November 1, 2022

ADDENDUM 2

Walnut Valley Unified School District
Diamond Bar High School
Building 400 Modernization New Classrooms/Library Media
DSA #03-121330 | File #19-H52

A2.01

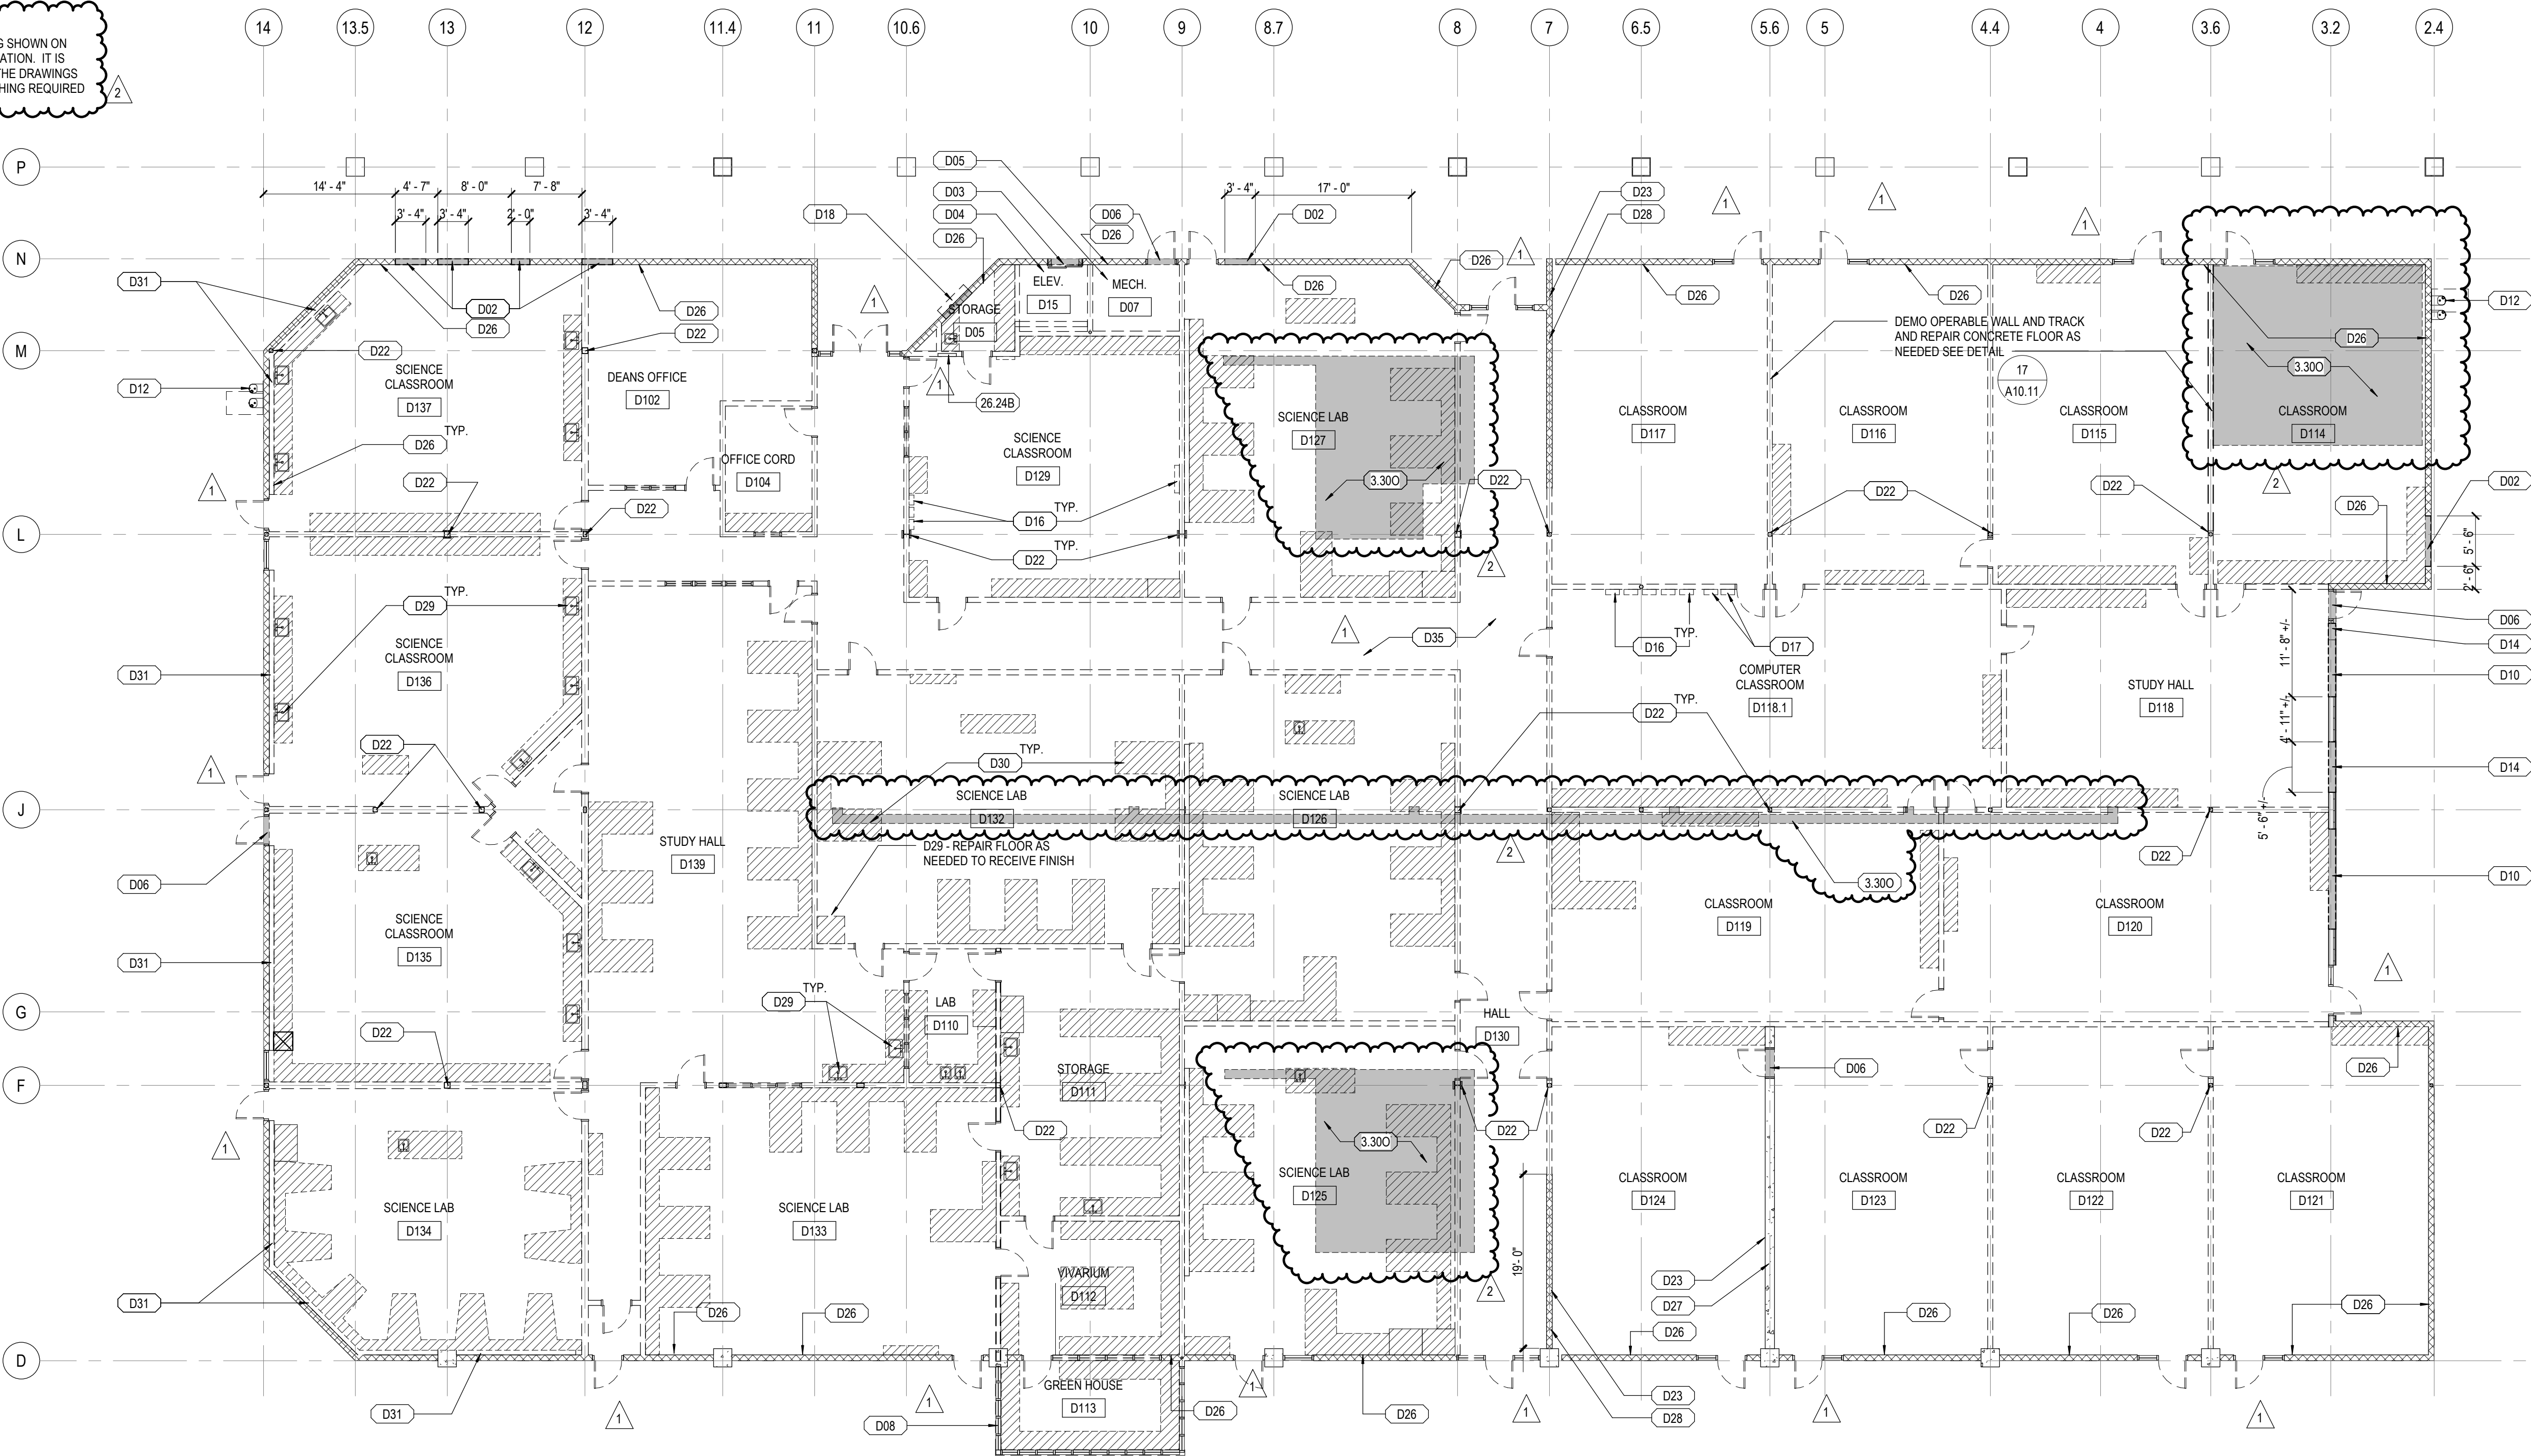
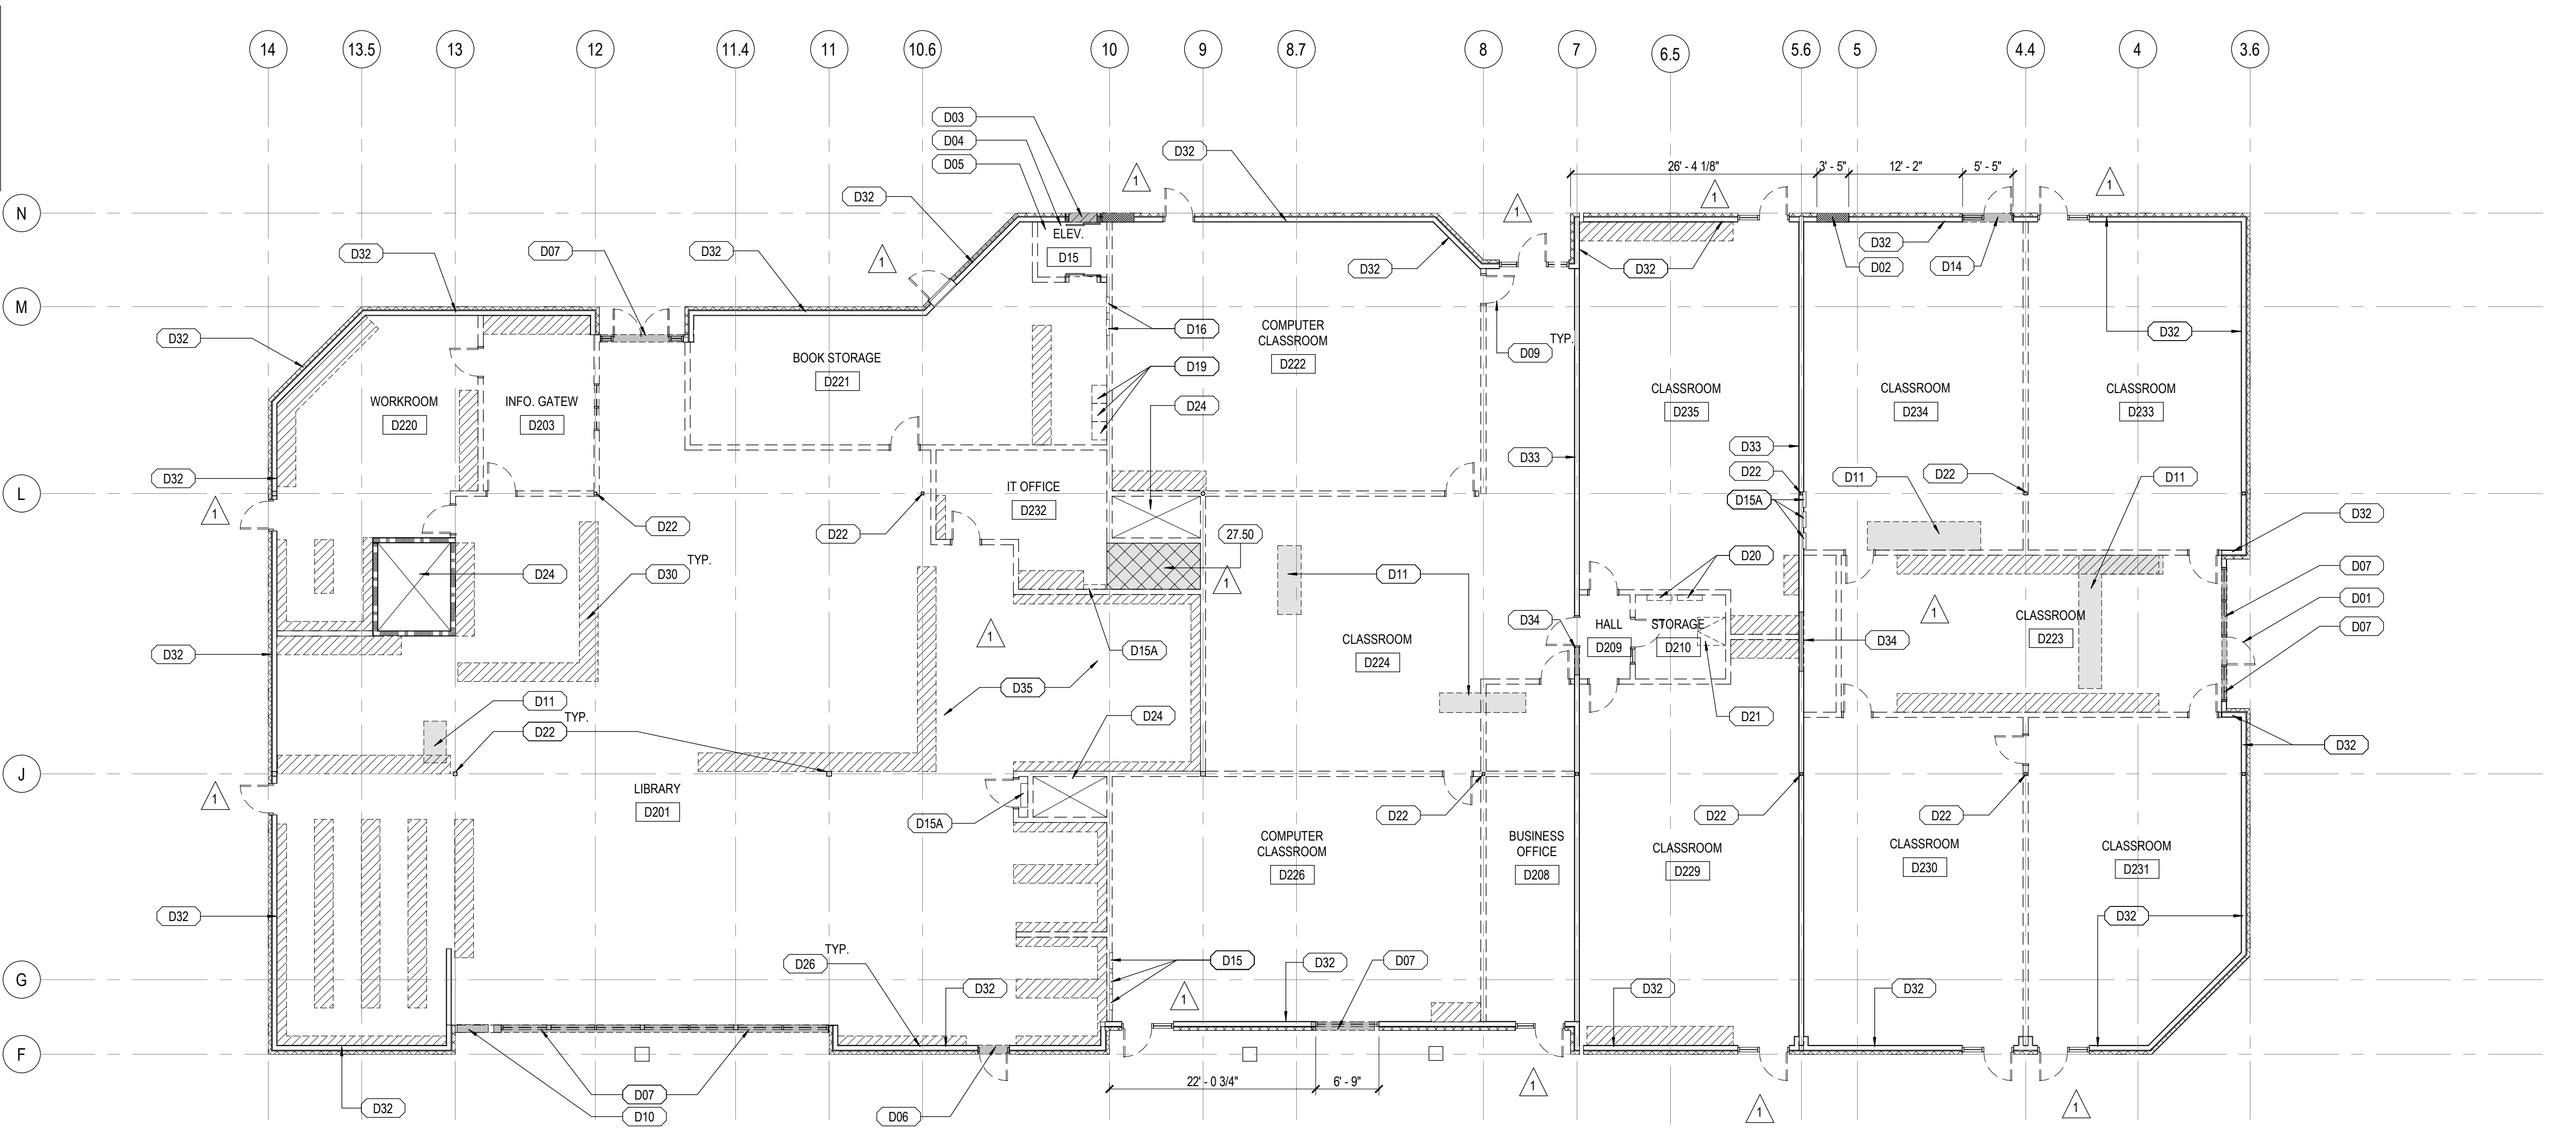
A2.01 DEMOLITION PLANS – LOWER LEVEL & MAIN LEVEL

- A. KEYNOTES: ADDED KEYNOTE 3.300
- B. 1/A2.01: ADDED AREAS FOR SLAB REMOVAL AND PATCH BACK TO INSTALL BELOW SLAB PLUMBING AND ELECTRICAL ITEMS

- DESCRIPTION
- 3.300 REMOVE PORTION OF (E) 8" CONCRETE SLAB ON GRADE FOR UNDER GRADE PLUMBING AND CONDUIT WORK. REPAIR AND PATCH WATER BARRIER AND CONCRETE. LOCATIONS SEE ELECTRICAL, PLUMBING AND MECHANICAL DRAWINGS.
